SUBJECT: Addendum No. 1
City of Lookout Mountain, GA
Chickamauga Trail Pump Station Improvements

ADDENDUM NO. 1

CHICKAMAUGA TRAIL PUMP STATION IMPROVEMENTS

CITY OF LOOKOUT MOUNTAIN, GEORGIA
GEFA LOAN NUMBER: GF2024017
CTI PROJECT NO. G24017-01

- LP LIGHTING PANELBOARD 120/240V, 100A, 3W, TINNED COPPER BUS, 20-CKT., NEMA 1, SURFACE MOUNT, WITH GROUND KIT. PROVIDE THE FOLLOWING CIRCUIT BREAKERS:
60A, 2P, MAIN BREAKER.
20A, 2P, HVAC UNIT.
30A, 2P, UNIT HEATER.
20A, 1P, RECEPTACLES.
15A, 1P, LIGHTING.
15A, 1P, FAN AND LOUVER.
15A, 1P, SPARE.

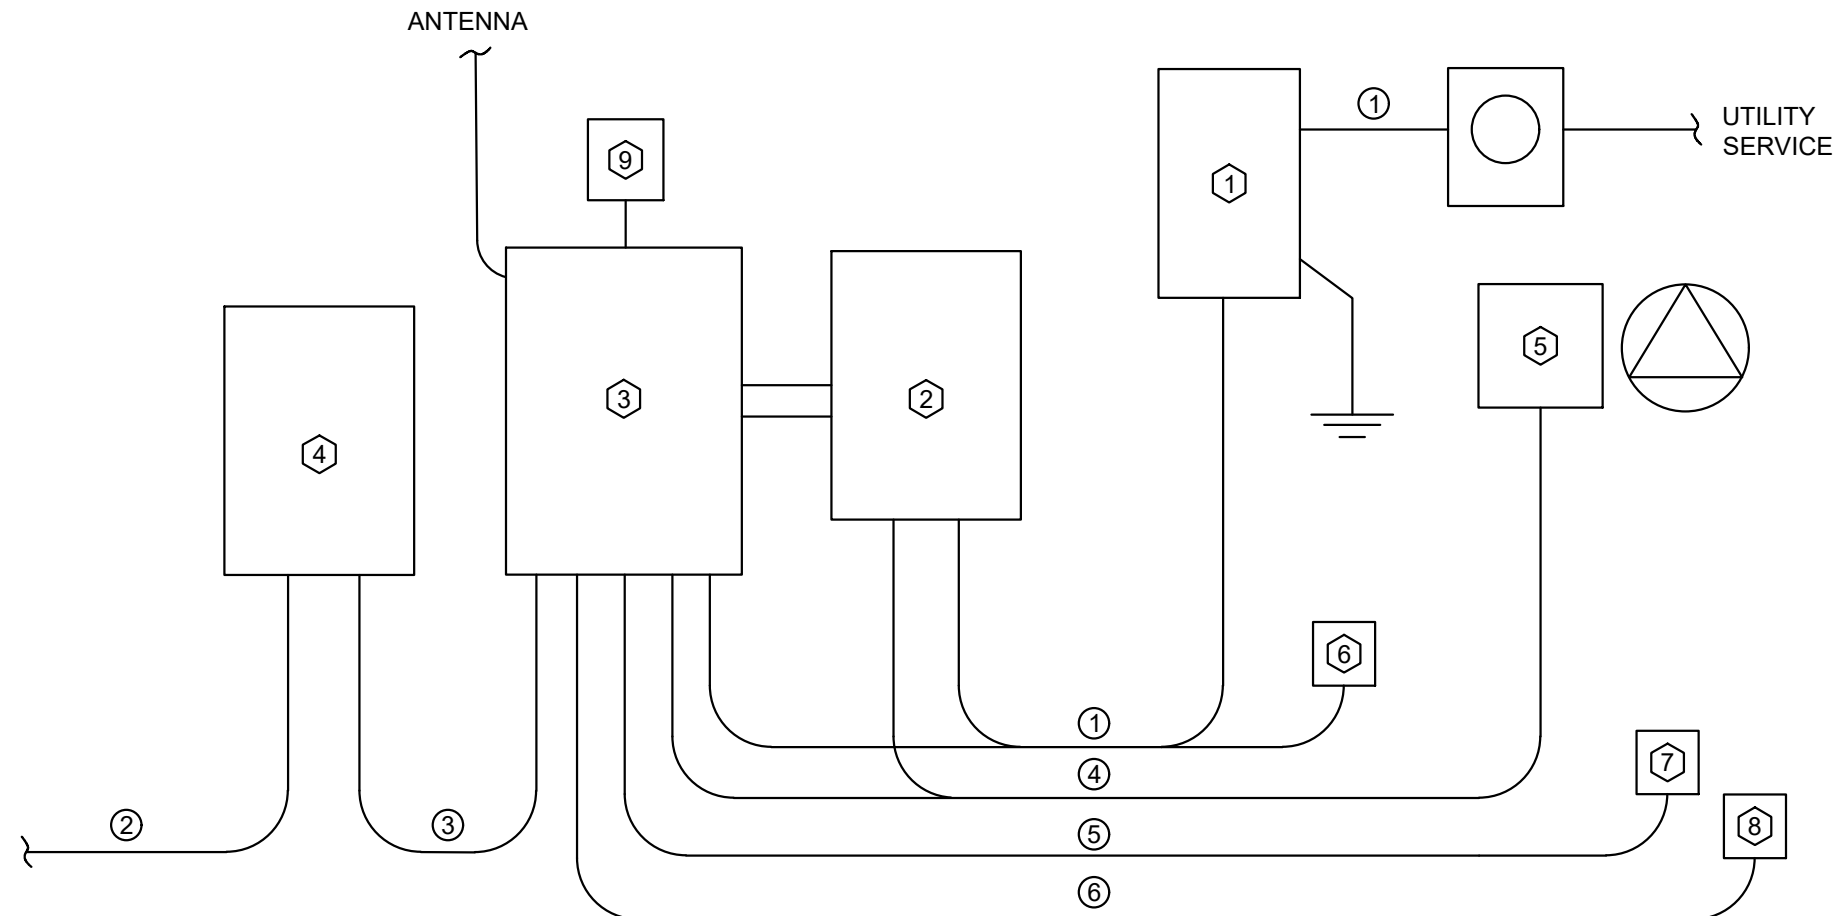
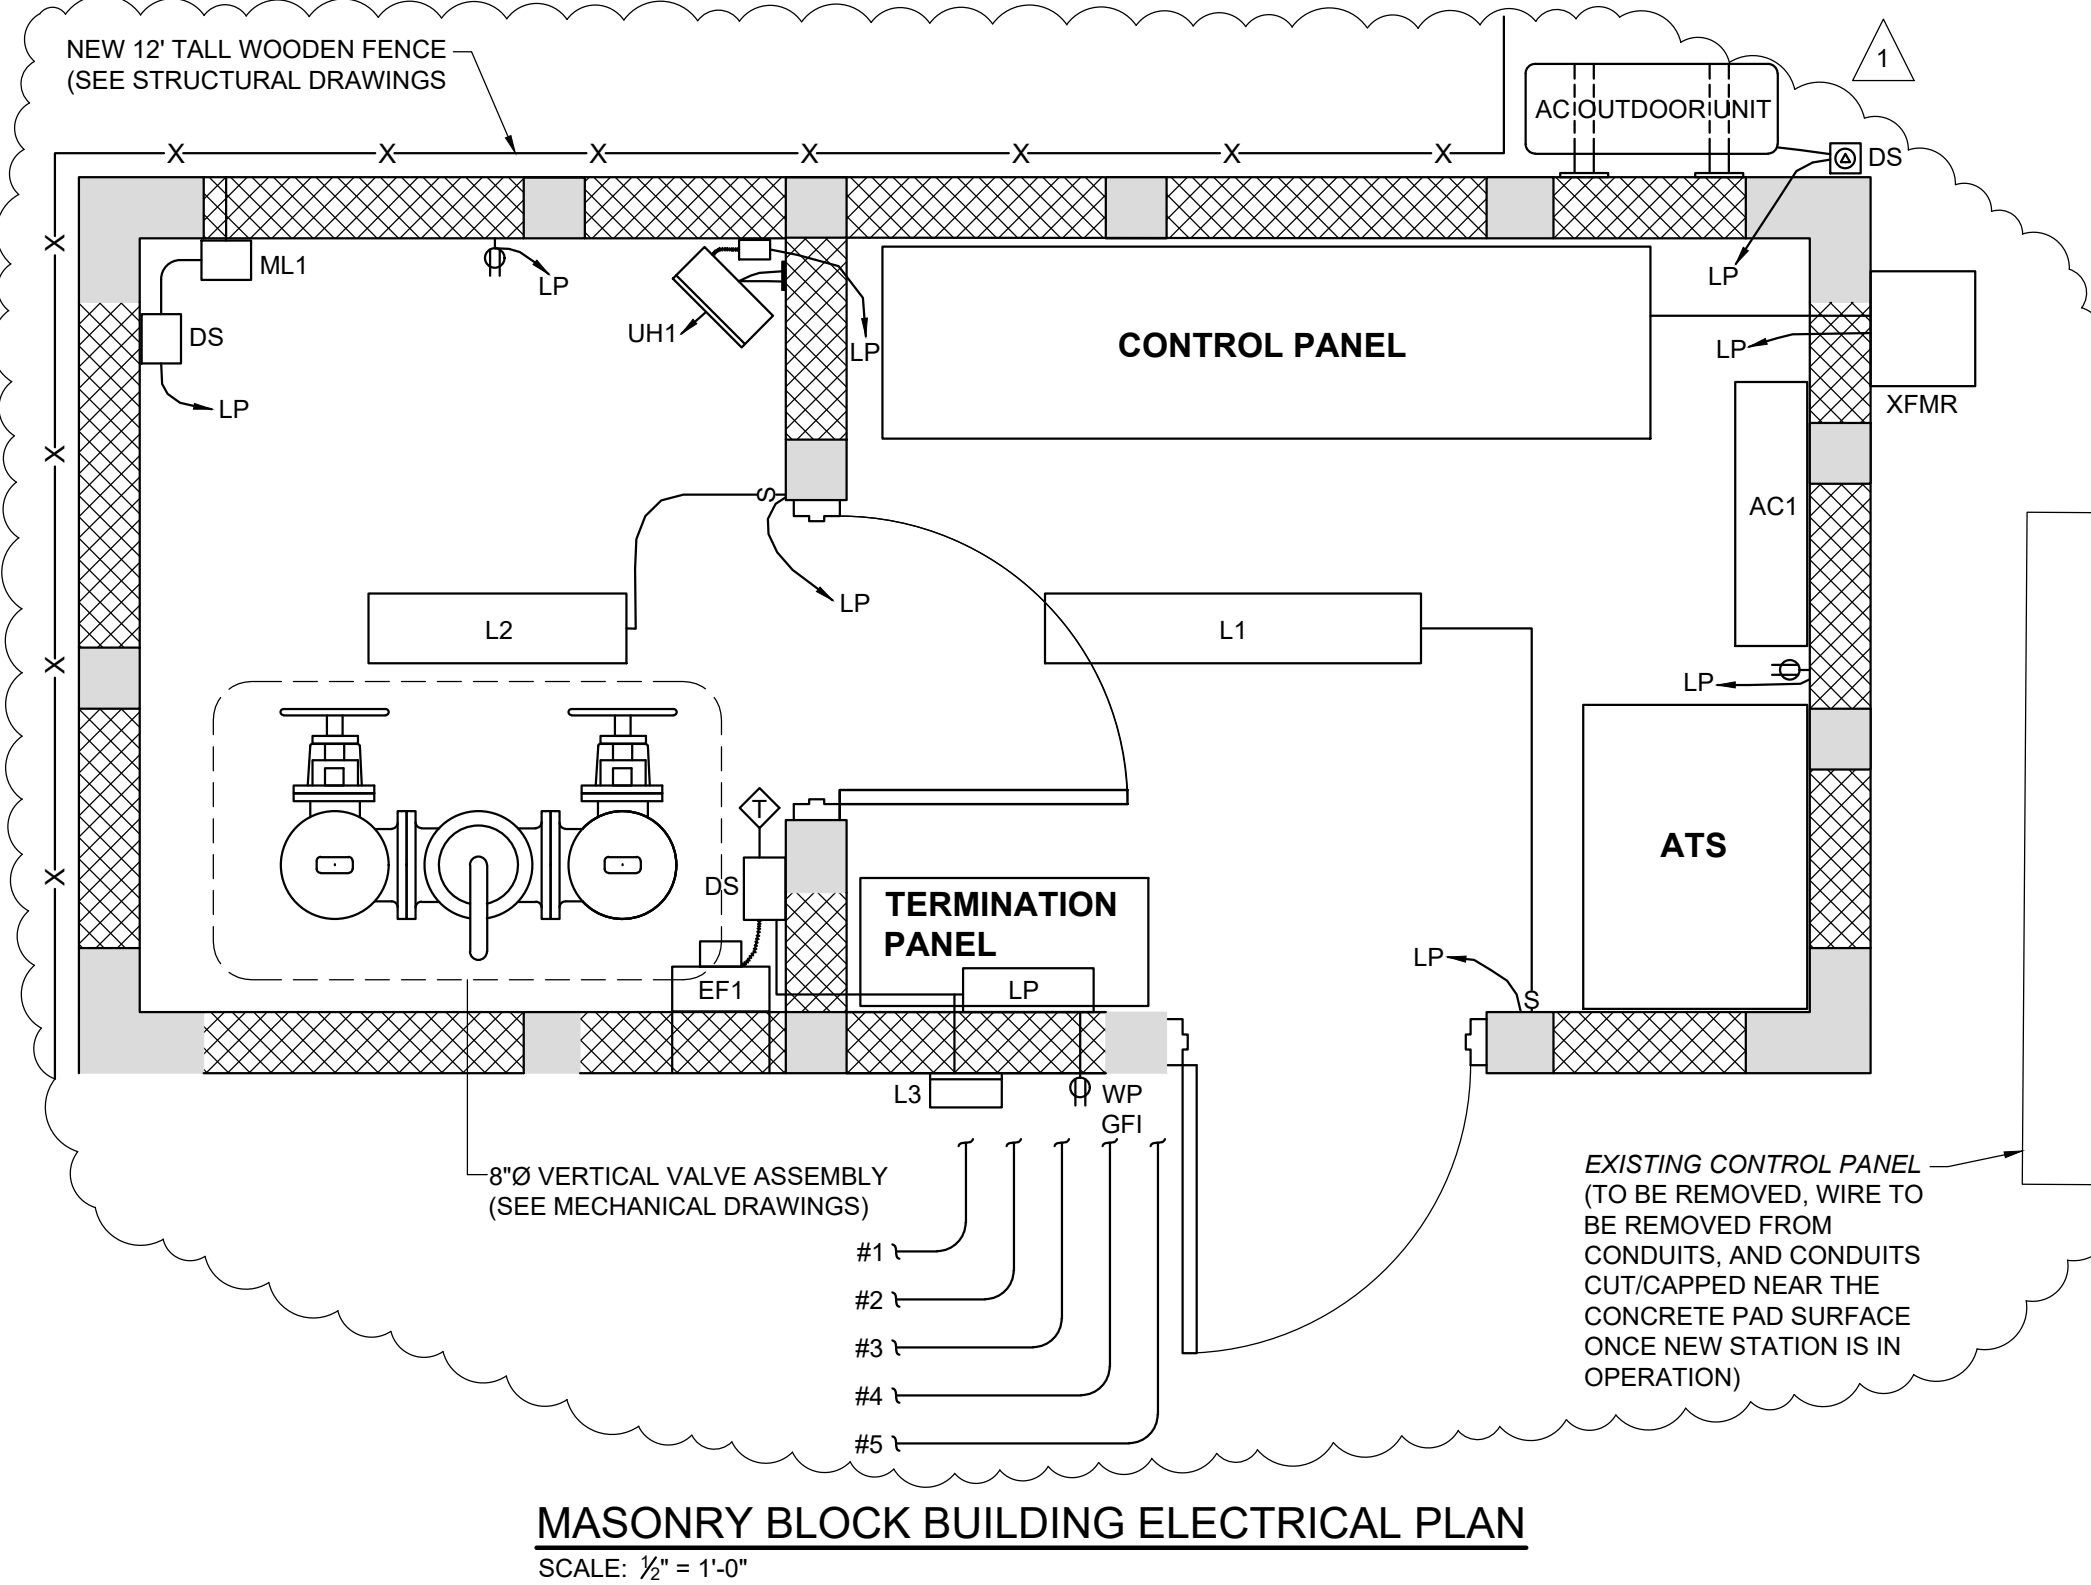
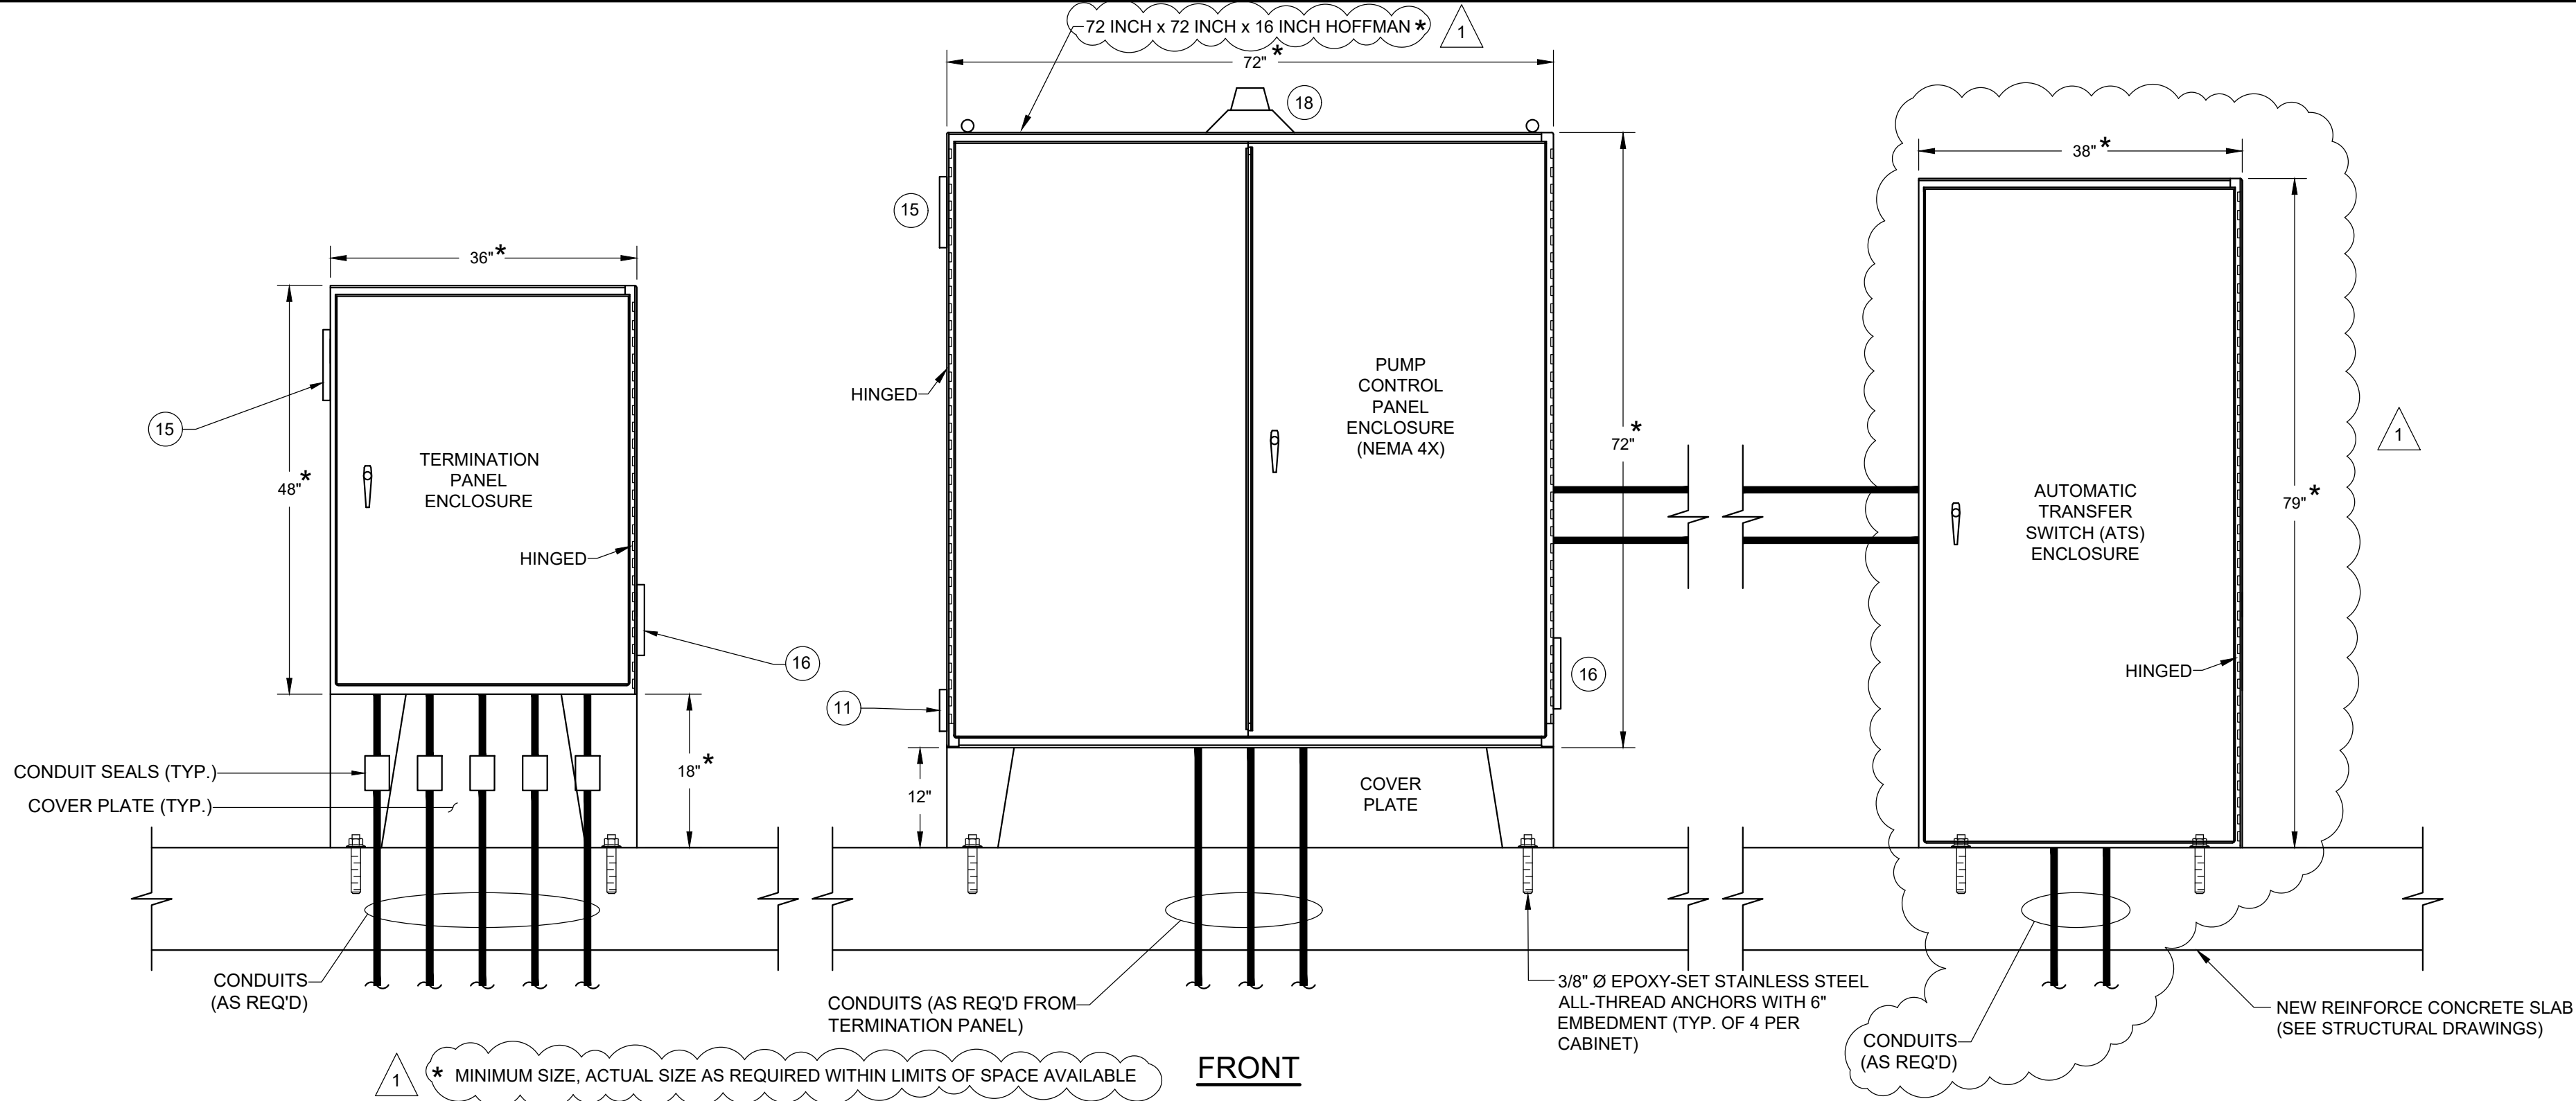
REVISIONS	DATE	BY	APPD	DESCRIPTIONS
1	08/25	GMC	GMC	LENGTHENED MASONRY BUILDING & REVISED BLDG ELECT HVAC LEGEND
